Prior to Release Conditions

Conditions of Approval

STANDARD BUS ZONE DIMENSIONS (Type A) (if sidewalk blvd < 2.1m) TRAFFIC FLOW ► Installation Dimension 25.0m Design Dimension 12.2m 7.8m 5.0m Tangent Parked car BUS ► to curve Boulevard (<2.1m) Route Identification Sidewalk 1.6m Sidewalk 9.0m Apron

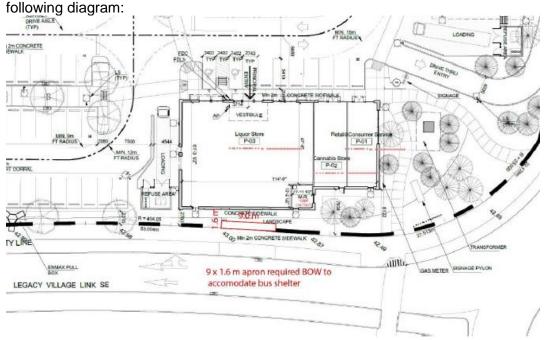
- 16. Amend the plans to include a 1.6m x 9m bus apron back-of-walk on the site to accommodate the bus shelter. The existing bus apron on SB Legacy Village Link SE at 210 Avenue SE does not meet design standards and is too small to fit a shelter while allowing space for passengers to align the bus. A public access easement is required along this strip of bus pad to allow the public to use the facility. Please refer to the
